DESIGN ADVISORY BOARD Tuesday December 13, 2016 at 3:00 PM Conference Room 12, City Hall, Burlington, VT Amended Agenda

RE: Great Streets Initiative – November 2016 Concept Plans for Main Street & City Hall Park

Review: City Hall Park Redevelopment Proposal, Burlington, VT

To: The Design Advisory Board
From: Mary O'Neil, AICP, Principal Planner
RE: ZP17-0623CA/MA, 329-375 North Avenue
Date: December 13, 2016

LANDSCAPE PLAN

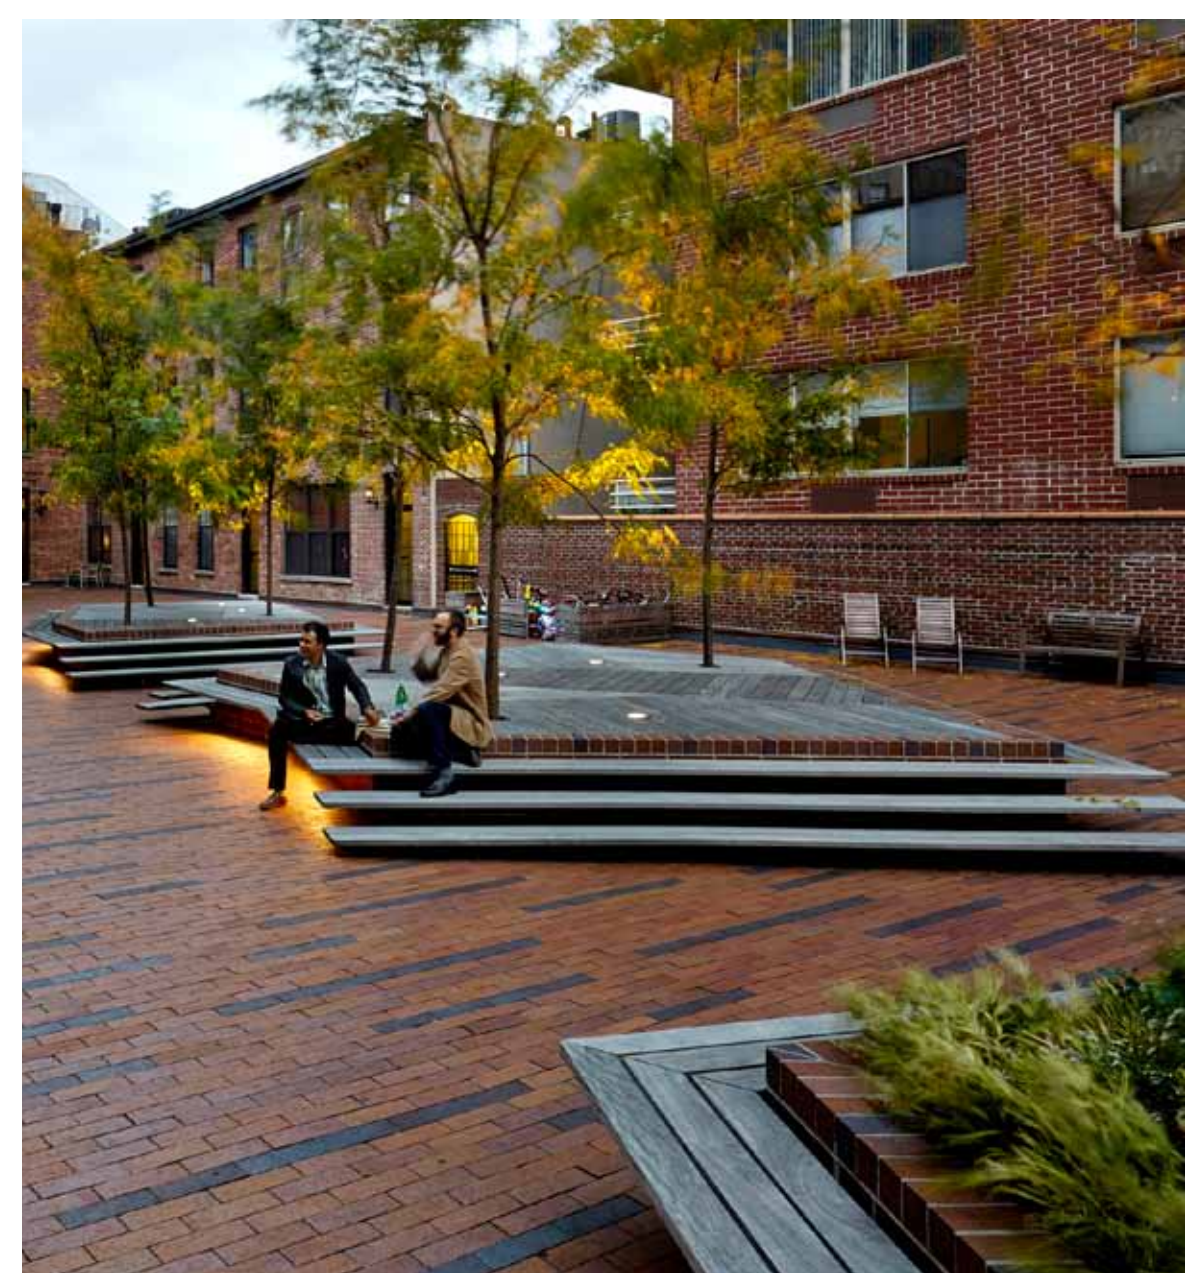
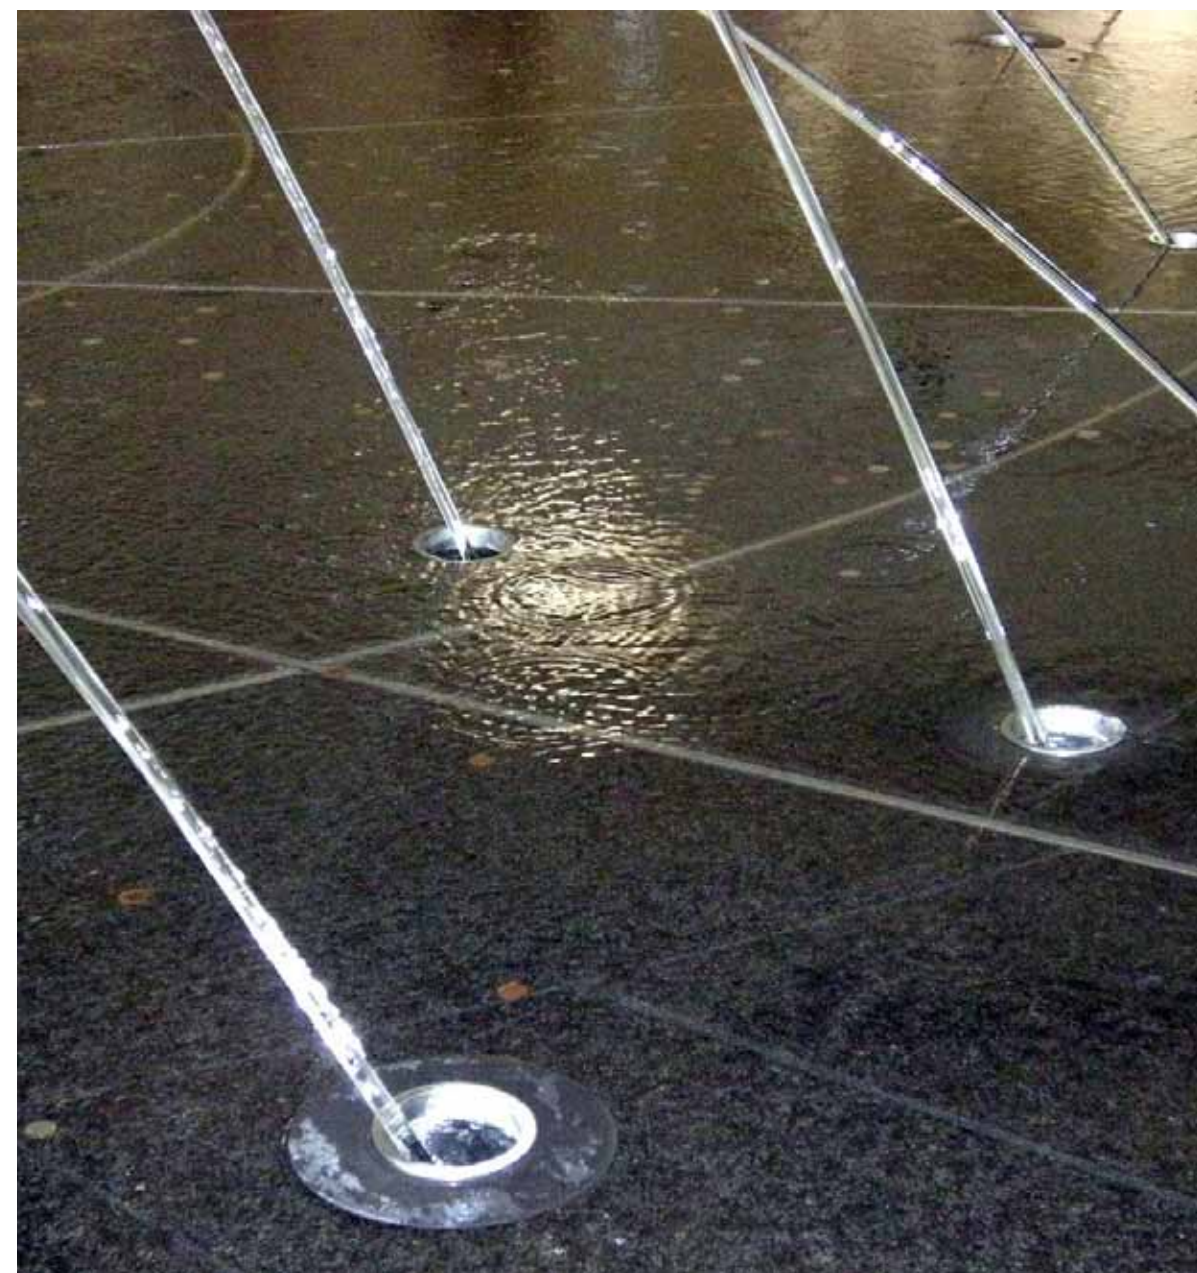
The proposed reconstruction plan retains many of these features. It contains a water feature and paths; however, the radial walkway pattern characteristic of the park is revised in favor of an asymmetrical walkway pattern with an off-center water feature. There is an argument to be considered that this arrangement is simply a contemporary interpretation of the evolving park layout and design, as it still achieves the same function of providing clear access into, and through, the park. A more historically appropriate layout would reflect the traditional radial walkway pattern with central water feature. To be clear, the materials and particular details of these elements are less important than the pattern. Revision towards a more radial pattern is recommended.

City Hall Park contains no significant natural features as defined in the Open Space Protection Plan. The park contains a number of mature trees. Most will be retained. Some; however, will be removed. A definitive tree-removal plan is not included in the sketch materials. One will be needed with the zoning permit application.

Contour lines are depicted on the sketch plan. There is; however, no differentiation between existing and proposed. Generally, it appears that topography will remain essentially unchanged.

The proposed reconstruction incorporates new stormwater management elements. While performance data has not yet been provided, the sketch plans depict two new rain gardens to capture and attenuate stormwater. The newly proposed "Park Lane" will be surfaced with permeable pavers. Performance data will be required upon application for the zoning permit.

Cambrian Rise
As modeled from the east

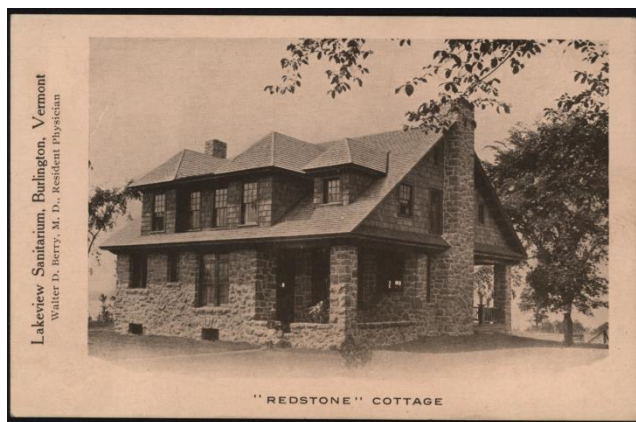
Openings vary by building, elevation, frontage to a public way or by topography. Overall, buildings have similar treatments of organizing windows in columns or reflective of floor plate. Rhythms are established within wall plane; the geometries of the building mass are echoed in the manipulation of window shapes and sizes. Greater complexity is evident in the buildings fronting the lake (M, N, O, P and Q.)

Much less detail has been afforded Buildings G, B, L and K. From the south, Building L resembles a warehouse in the almost regular arrangement of uncased openings and Spartan simplicity of its four stories. Its starkness is emphasized in the immediate juxtaposition with a 1 ½ story cottage.

Some window arrangements do not maintain consistent patterns (see pavilions of L); other buildings have a more discernable schedule. (Building M, where the window refrain is repeated across the façade and around the corner.) Window variations sometimes occur as buildings turn corners or are modeled as separate volumes, like Building H or C. Openings appear more vertical than horizontal.

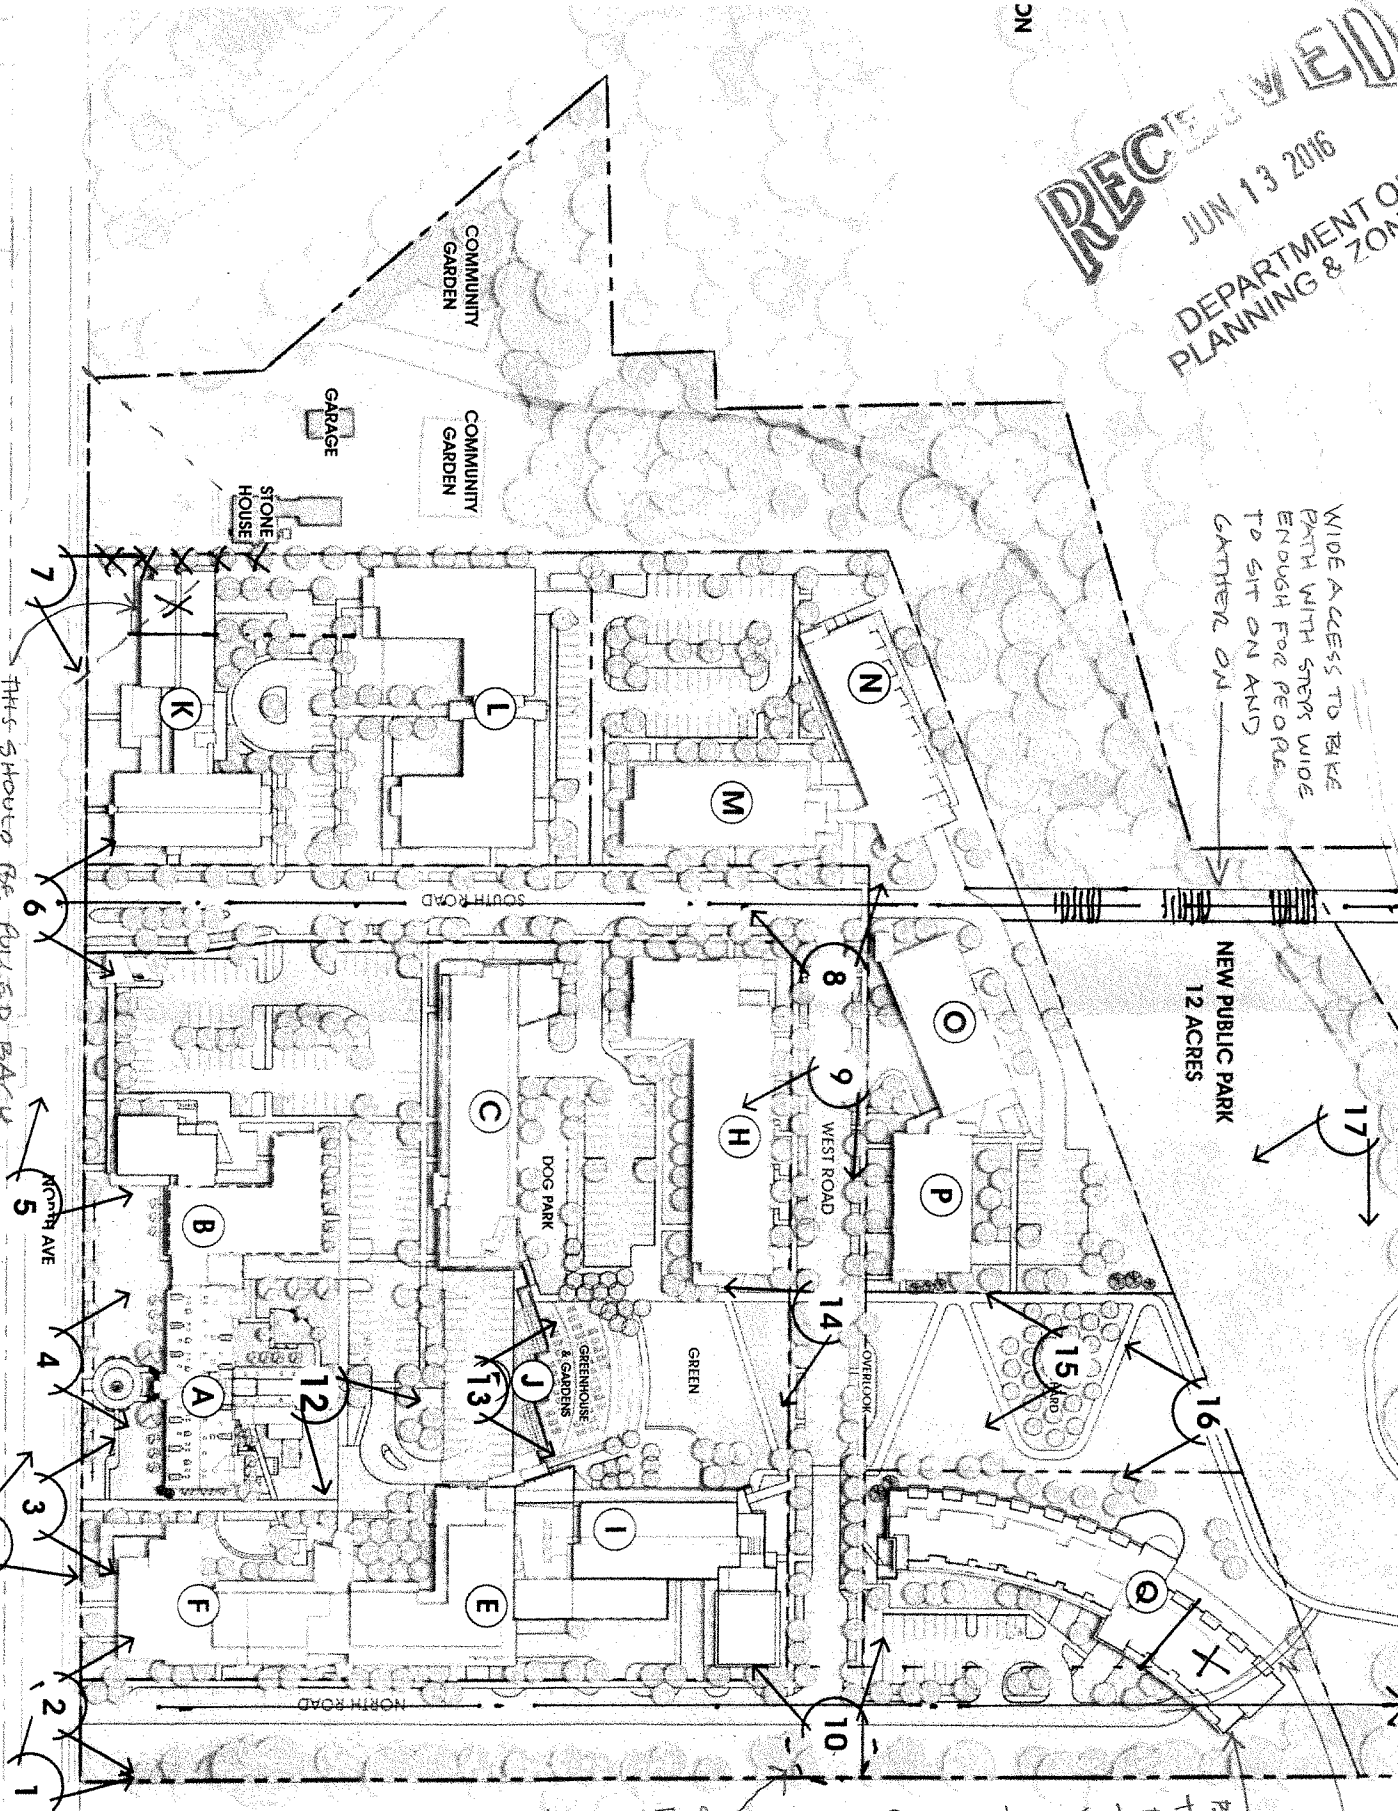
WIDE ACCESS TO TAKE
PATH WITH STEPS WIDE
ENOUGH FOR PEOPLE
TO SIT ON AND
GATHER ON

SOME
SPECIAL
PLANTING
WOULD BE NICE
HERE TO
PROVIDE A
TERMINUS FOR
WEST ROAD.
